U. S. Department of Labor

May 6, 1983

I am writing this letter to you to provide information with regard to the acoustic field evaluation that was conducted at Copper Valley Mining Company, No. 6 mine, located near Elderton, Pennsylvania. This evaluation, which was conducted during the time period from February 23, 1983 through March 9, 1983, dealt with a Wilcox Mark 20 auger miner system and a set of modified, sand filled cutting heads. These cutting heads were leased to the Physical Agents group for the purpose of the evaluation.

Letter to Mr. L. C. Marraccini, 04/26/83, Subject: Reduced-noise auger miner cutting head problems investigated by Wyle Laboratories and Bureau of Mines personnel

FIGURE 1. - Operator Position, cut and load

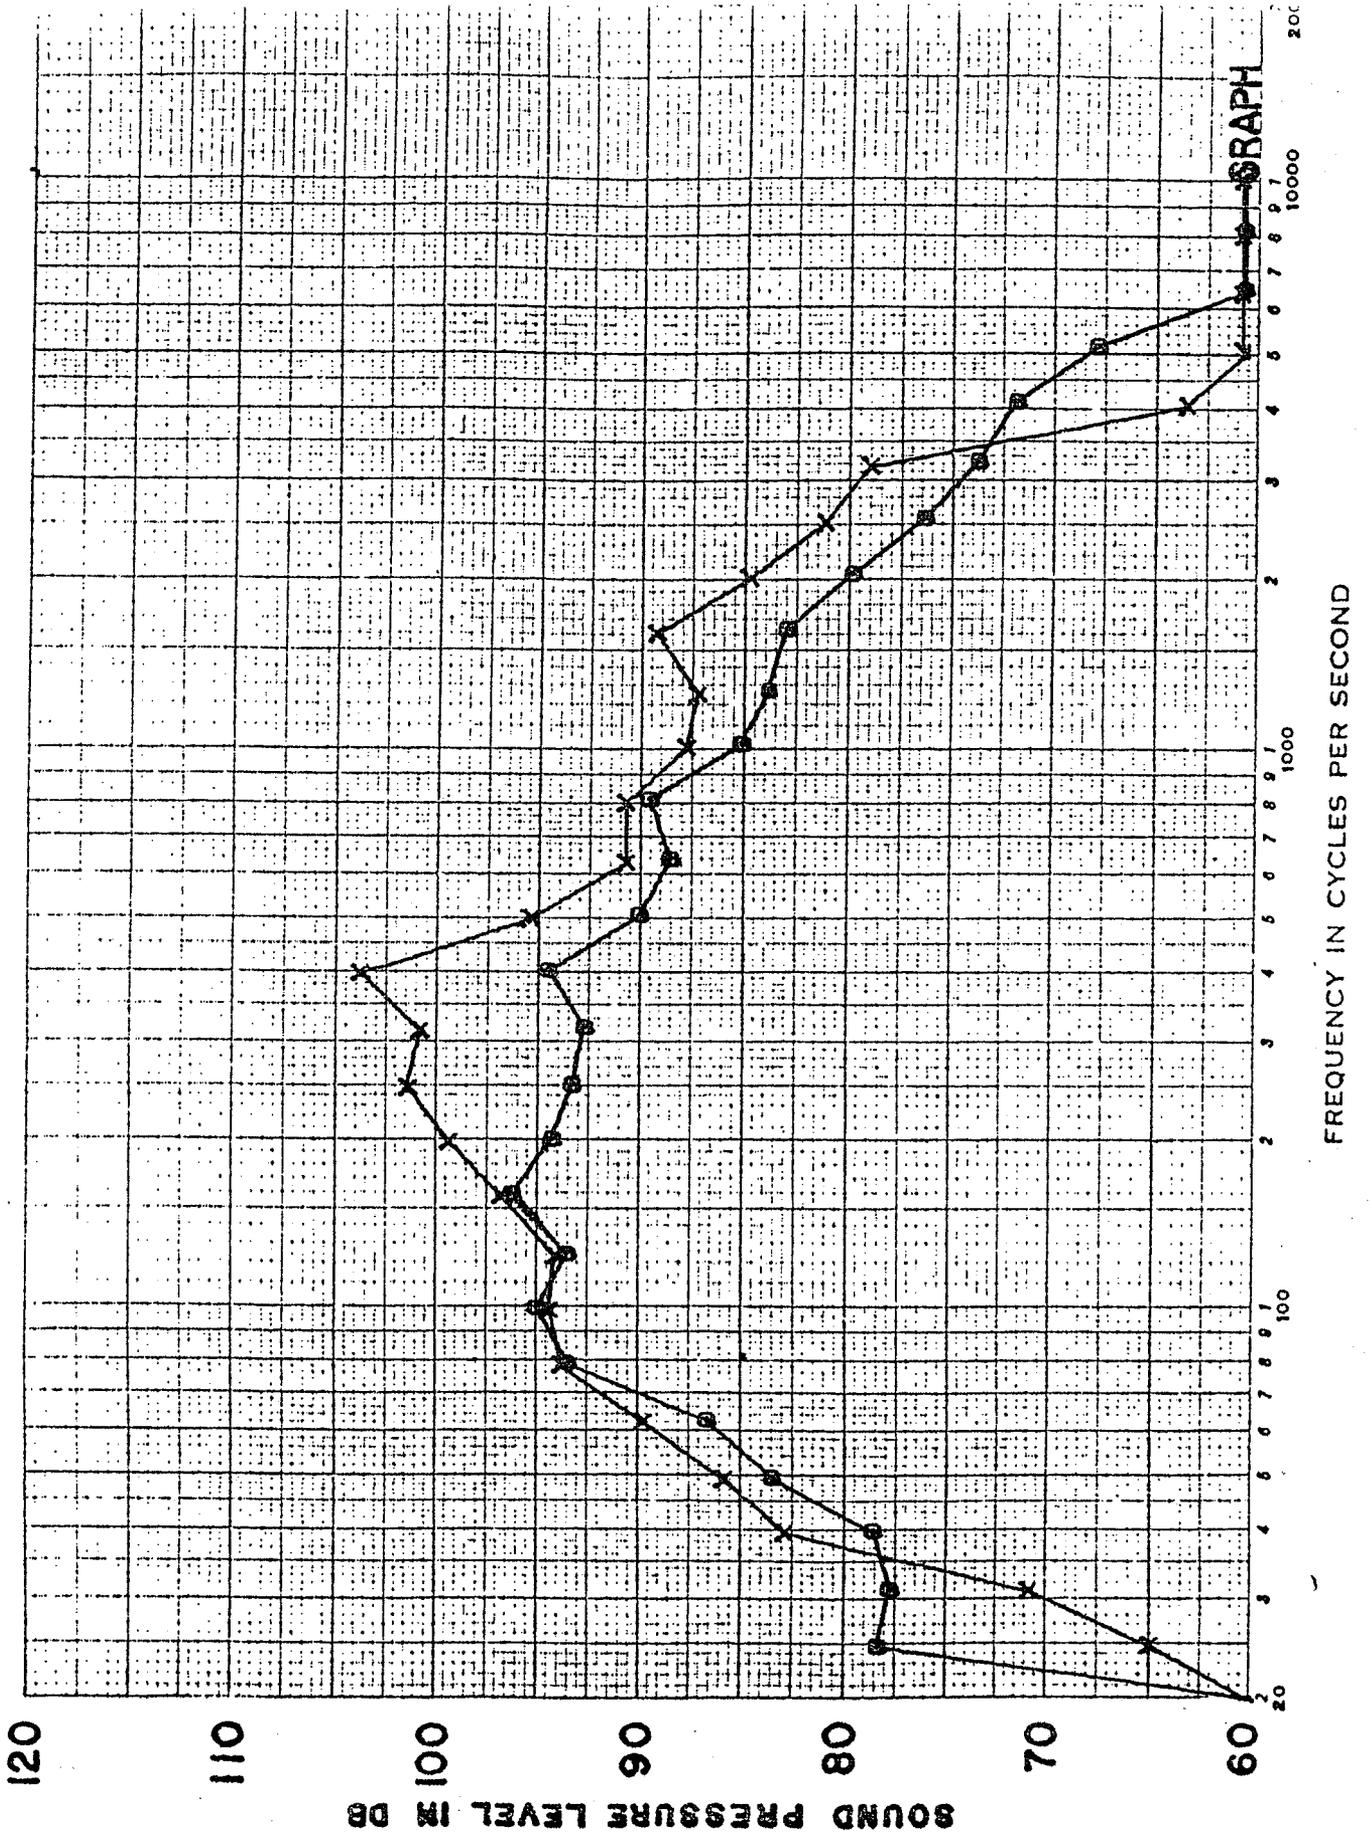
As can be seen, there was a significant noise reduction due to the cutting heads. To further illustrate this reduction, enclosed with this letter are charts showing the frequency distribution of the noise.

Figure 1 - Flat face profile resulting from "old" augers

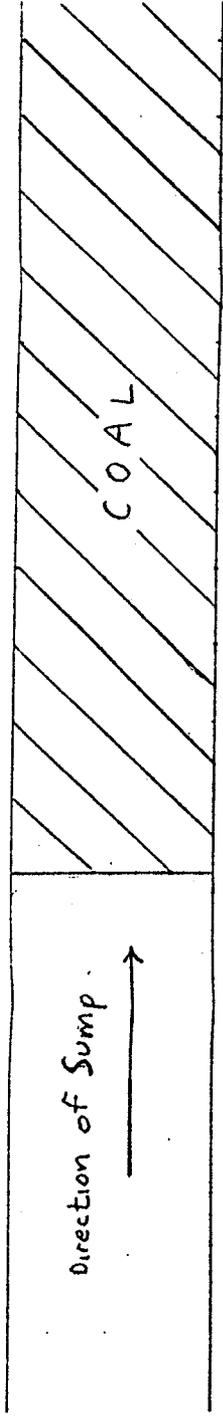
Figures 1 through 4 show how the "ridge of coal" problem could have occurred. Because of the smaller head castings of the "new" augers, the profile of the finished coal face assumed a more concave shape than with the "old" augers (Figures 1 and 2). The machine operator at Copper Valley would not have expected this, so he sumped the Wyle augers until the outby bits were fully "buried" into the face, as was standard practice with the "old" augers (Figure 3). This placed the outby bits slightly inby the point at which the face became concave. When the operator raised the lead auger and lowered the trailing auger to begin his sweep toward the rib (Figure 4), a ridge of coal was left behind the outby bits.
